## SAM'S CARWASH CONDITIONAL USE NO. CU202503

### Conditional Use Application

Sam's Carwash, Conditional Use Application No. CU202503– Request for Conditional Use approval to allow a Car Wash in the CRT-1.75, C-1.0, R-0.75, H-55 Zone, located at 26203 Ridge Road, Damascus.

Exhibit 17

**CONDITIONAL USE PLAN**

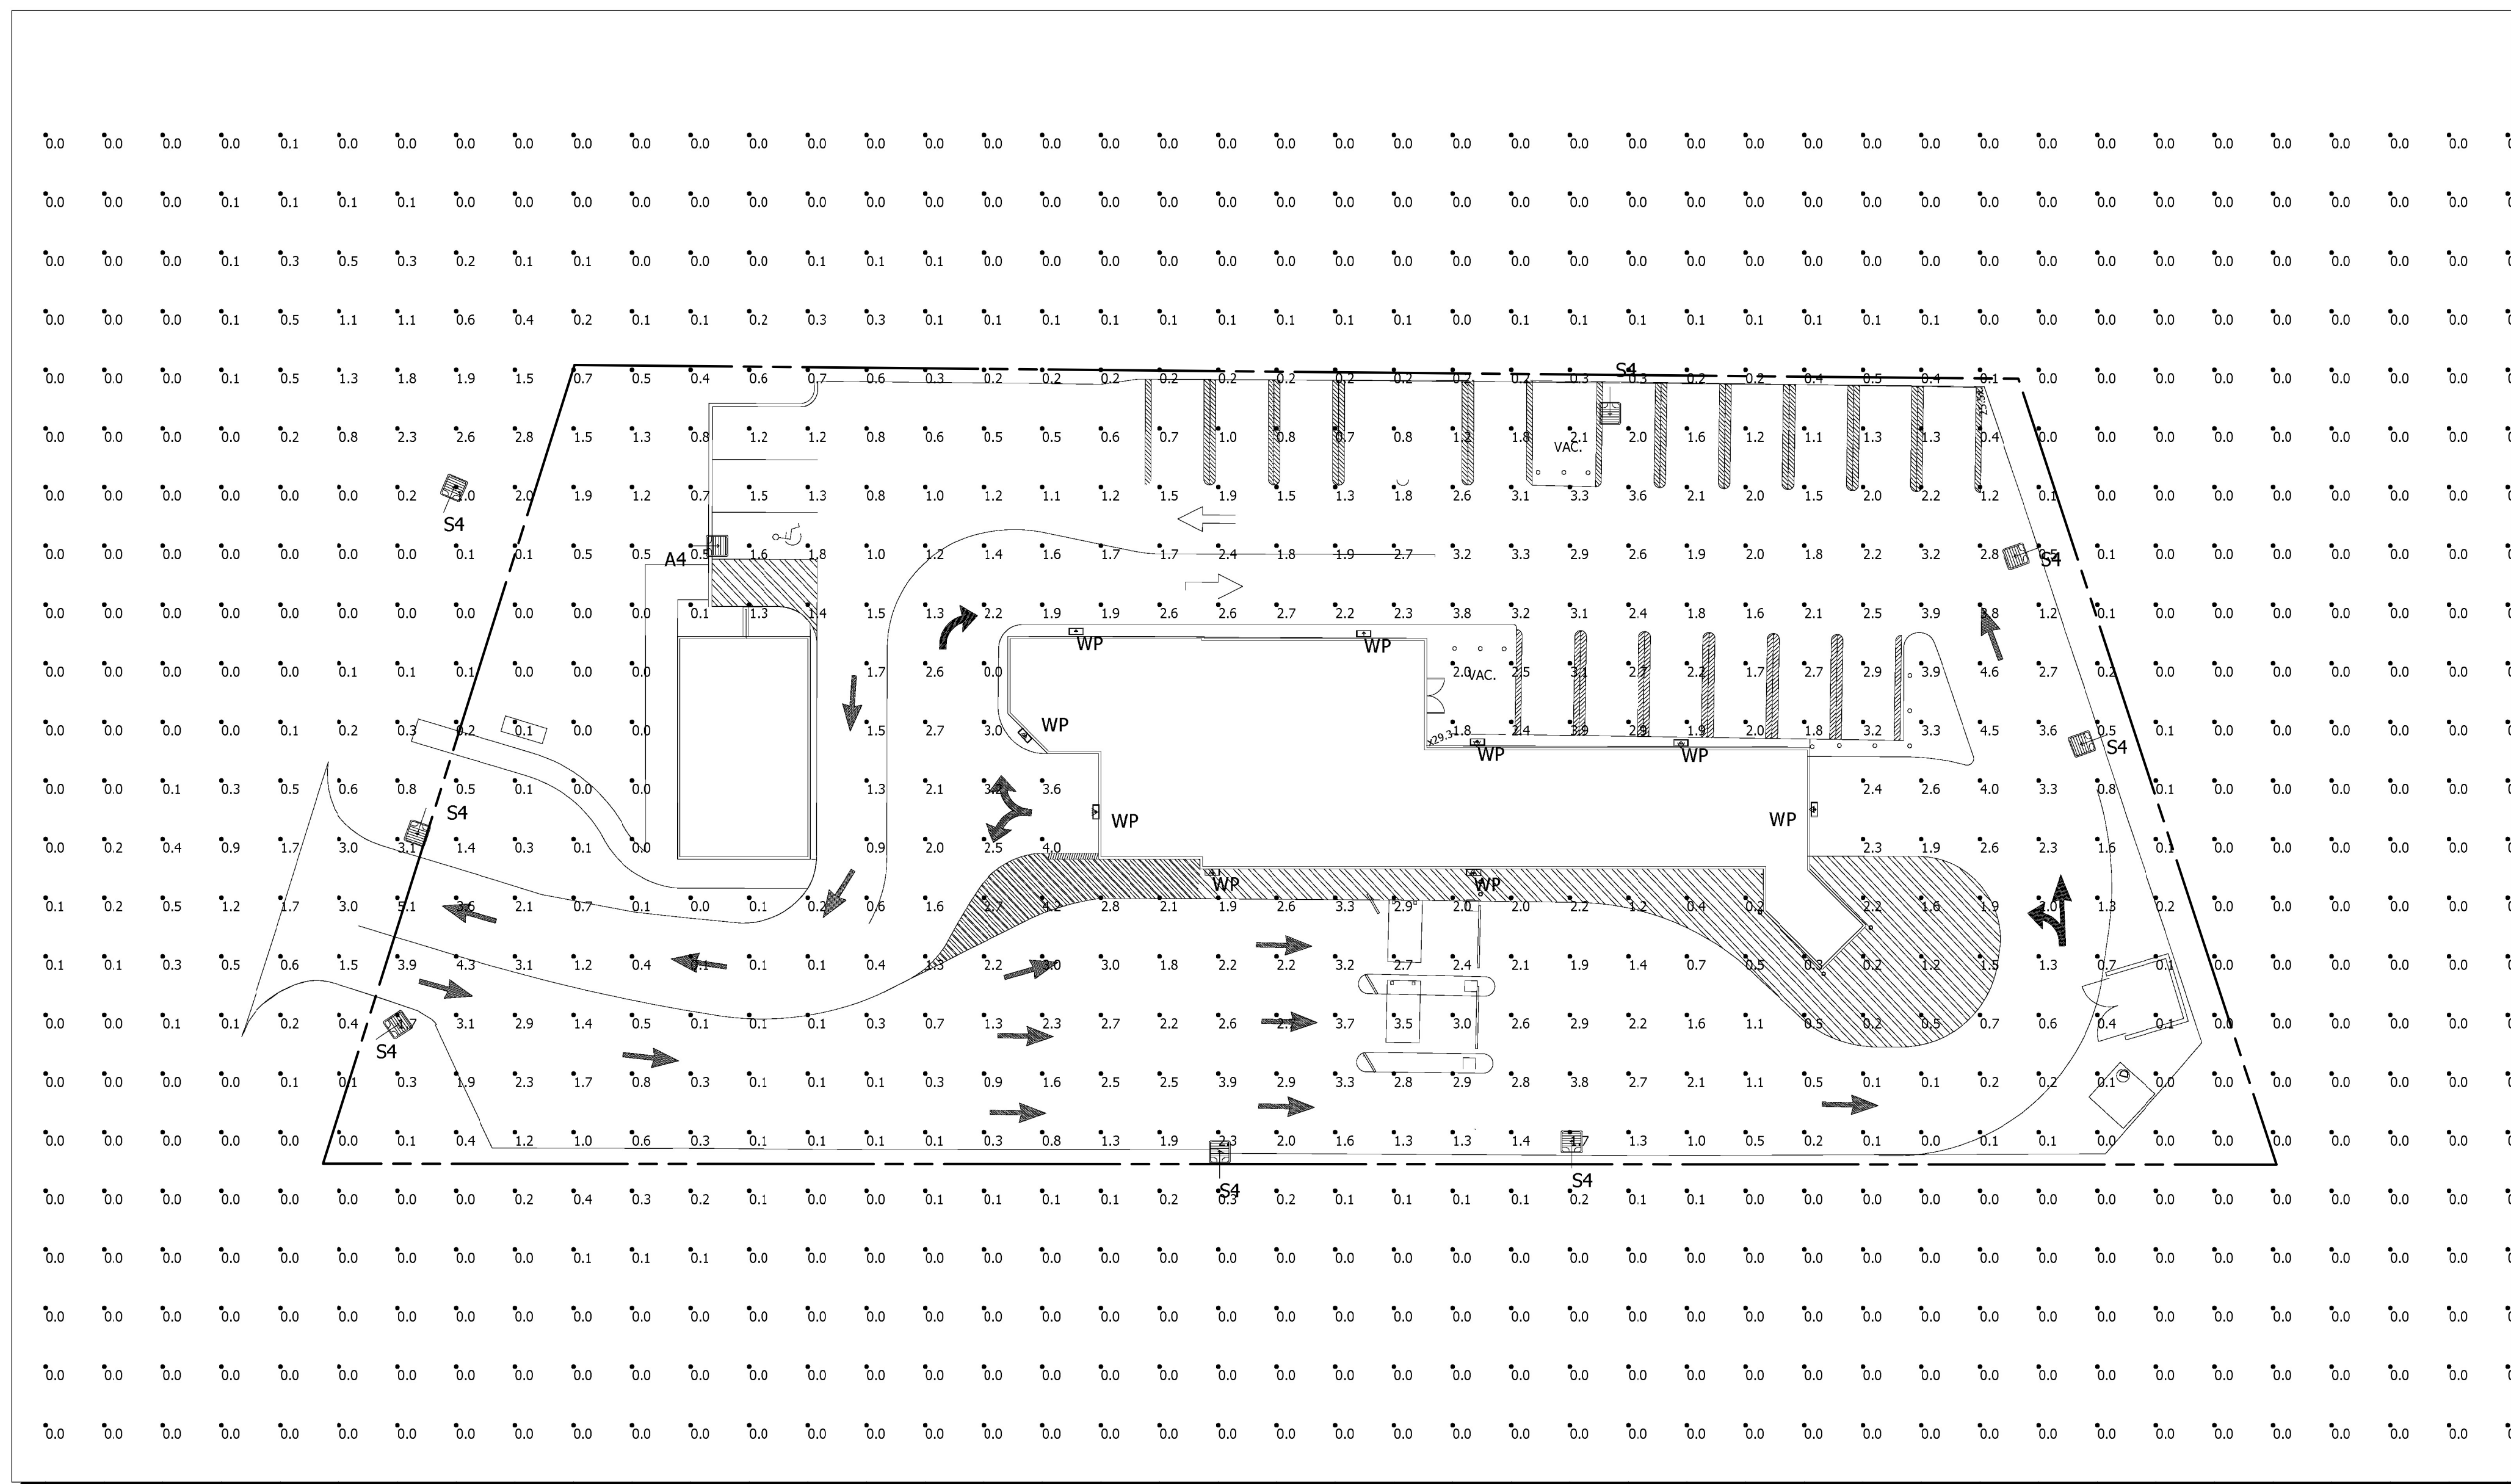
We have completed our review of the updated conditional use plan dated February 7, 2026, which was received via email on February 25, 2026. A previous version of this plan was reviewed by the Development Review Committee at its October 8, 2024, meeting. This plan is tentatively scheduled for the March 26, 2026, Planning Board hearing. We recommend approval of the plan subject to the following comments:

2. Ridge Road (MD 27) is classified as a town center street with a minimum right-of-way (ROW) of 80-feet. We recommend that the applicant dedicate forty feet from the existing centerline to comply with the master plan.
